Subject: License No. SUB-1010, Docket No. 040-08027
Reclamation Plan Acceptance Review, Request for Additional
Information

ENCLOSURE 1
Sequoyah Fuels Corporation
Reclamation Plan Acceptance Review
Request for Additional Information

SFC Responses to Request for Additional Information
August 8, 2003

Figure 3.1 Geologic Provinces of Oklahoma (From Northcutt and Campbell, 1995)

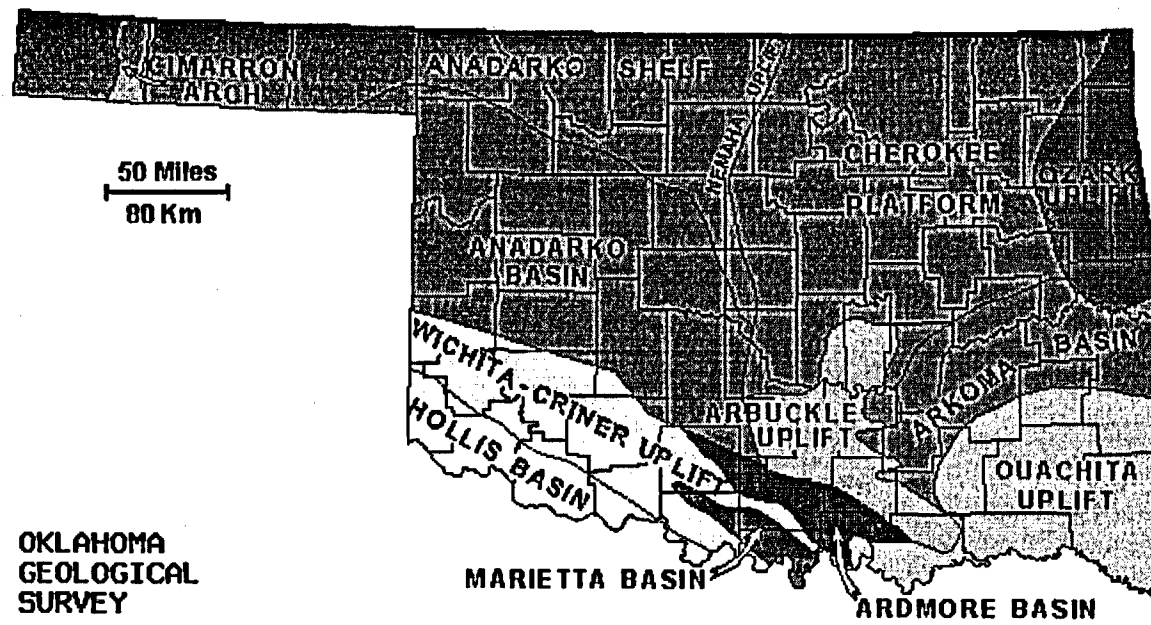
As shown on Figure 3.1 of The revised Appendix E of the Reclamation Plan, the SFC Facility is located at approximately the contact between three tectonic provinces: (1) the Ozark uplift, (2) the Cherokee platform, and (3) the Arkoma basin. The Black Fox Nuclear Power Plant (NPP) site is within the Cherokee platform tectonic province.

FIGURE 3.2
FAULTS WITHIN FIVE MILES RADIUS OF SITE
 (ADAPTED FROM FIGURE 9 OF FRI, 1997 AND VAN ARSDALE, 1998)

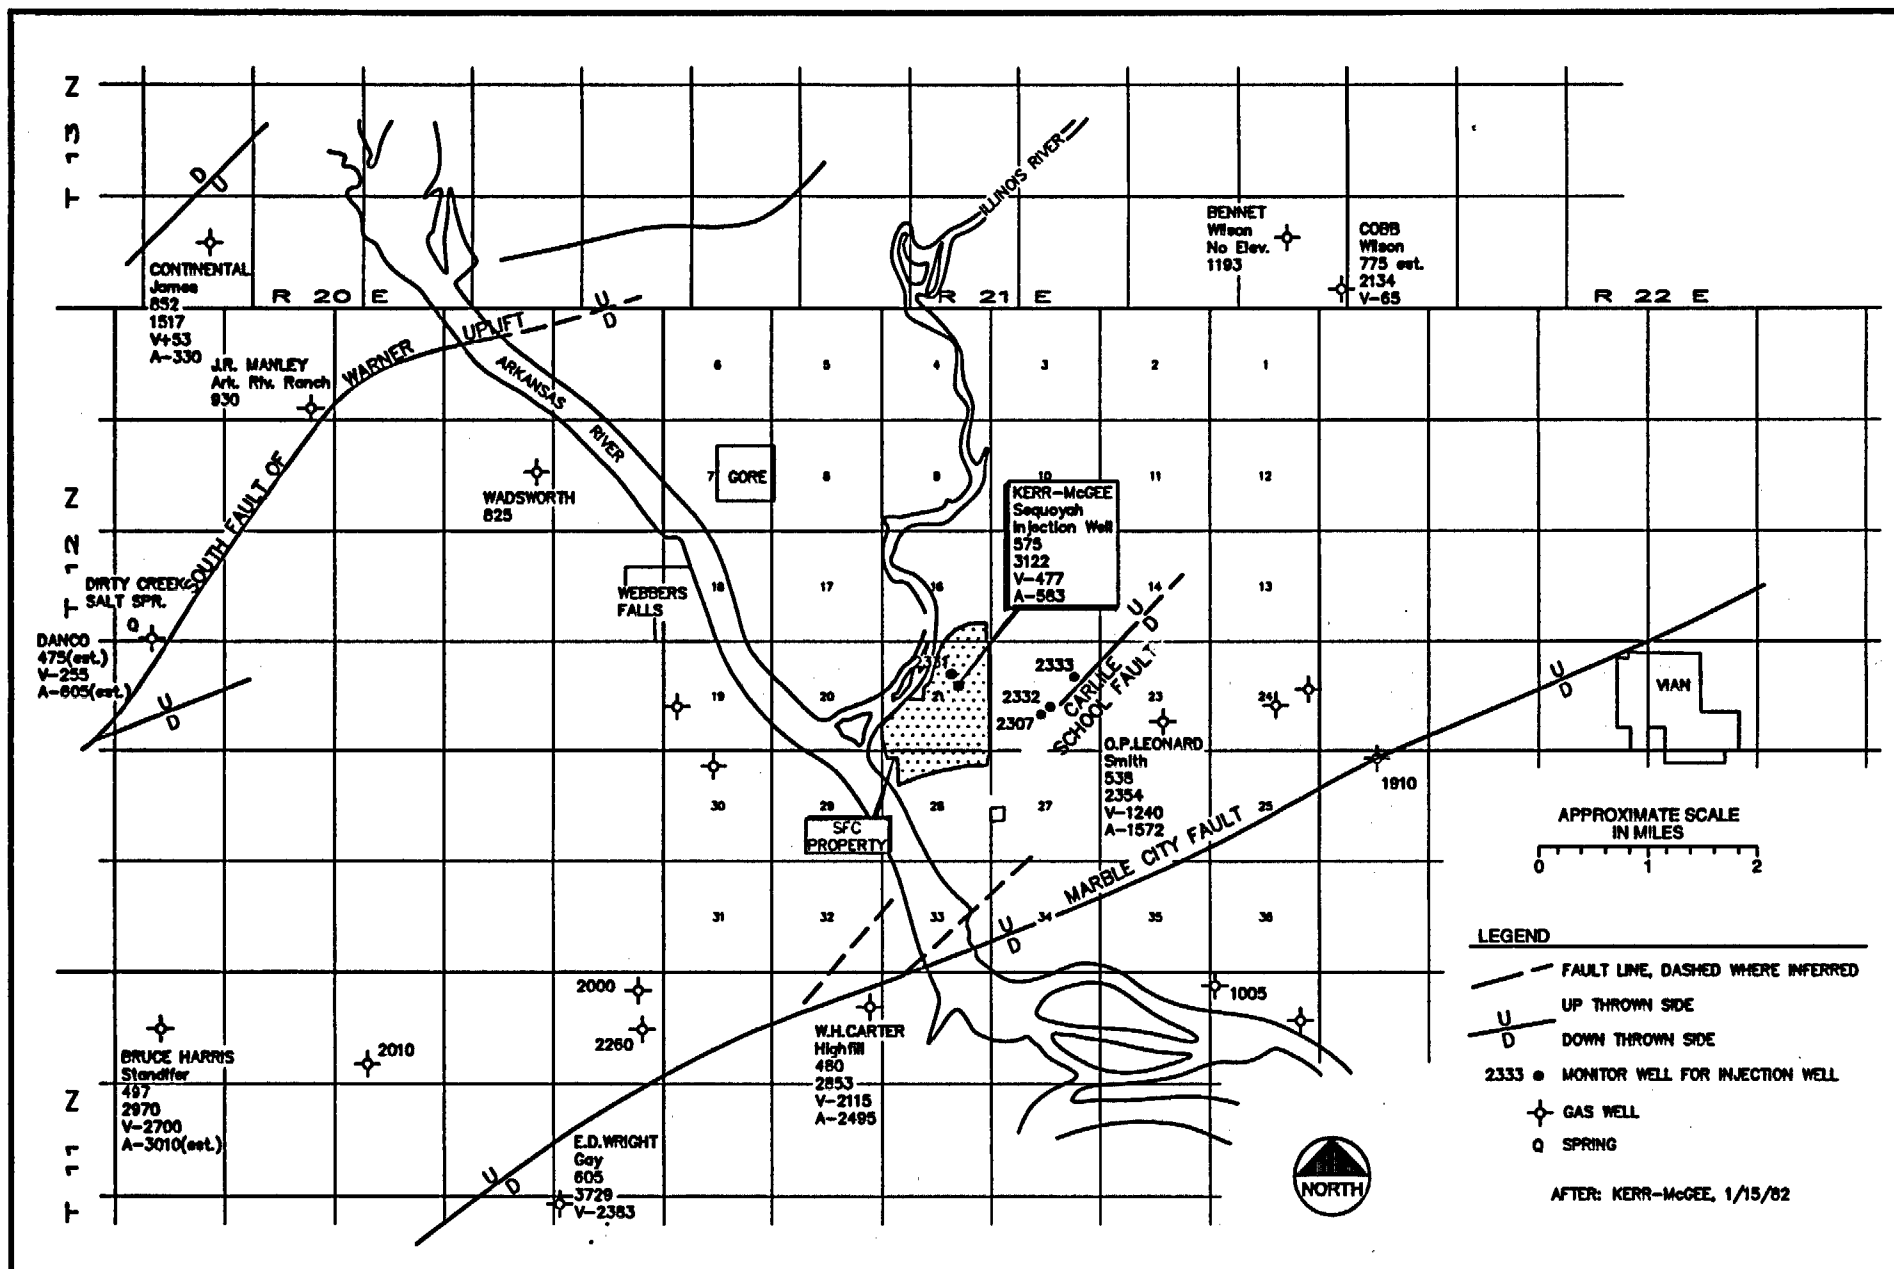
Figure 3.2 shows all known faults within 5 miles of the SFC Facility, as presented in SFC (1997b). These faults include: (1) the Marble City Fault and its splay (MCF), (2) faults associated with the South Fault of Warner Uplift (SFWU), and (3) the Carlile School Fault. NRC concluded that none of these faults are capable faults (NRC, 1998a), as discussed below.

FIGURE 6.1
FACILITY TOPOGRAPHY MAP

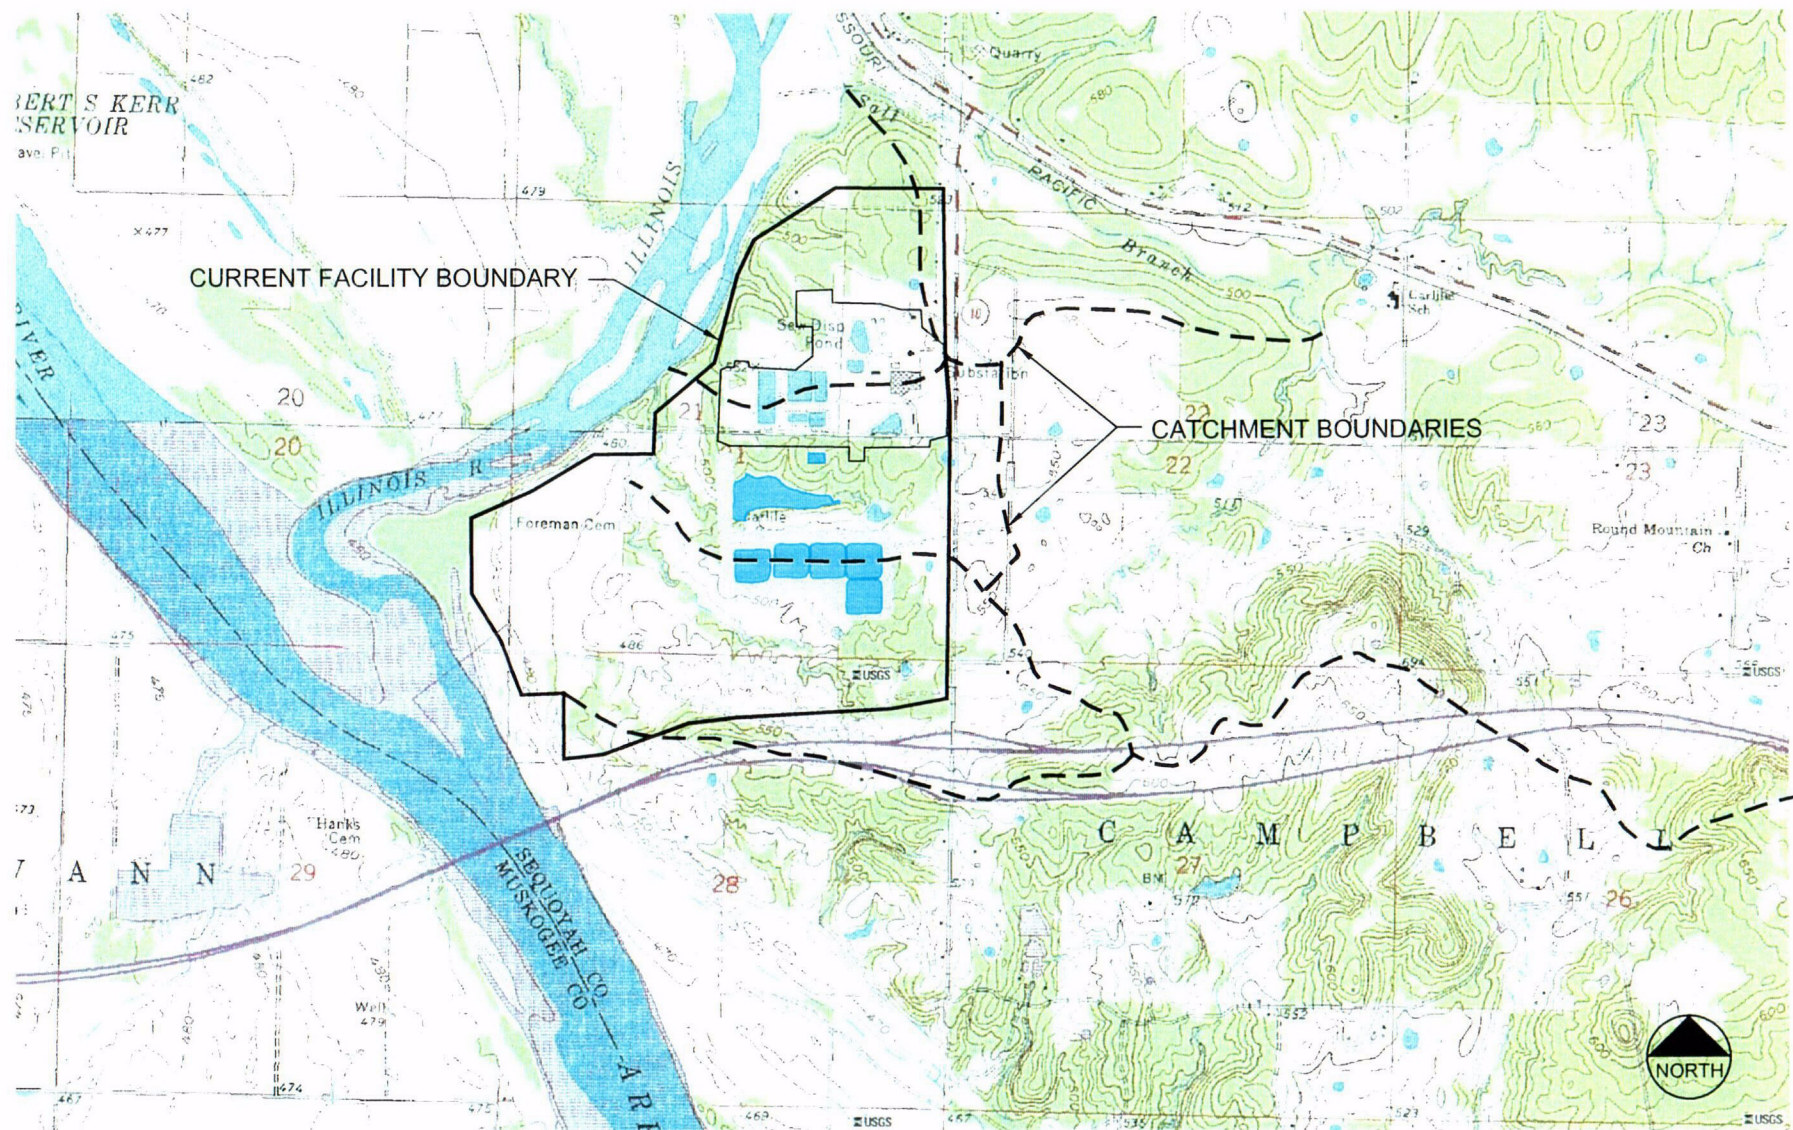
- SW4. Provide maps and/or drawings delineating sub-basins on and near the impoundment.**

This basin delineation map is provided in Section 6 of the revised Appendix E of the Reclamation Plan.
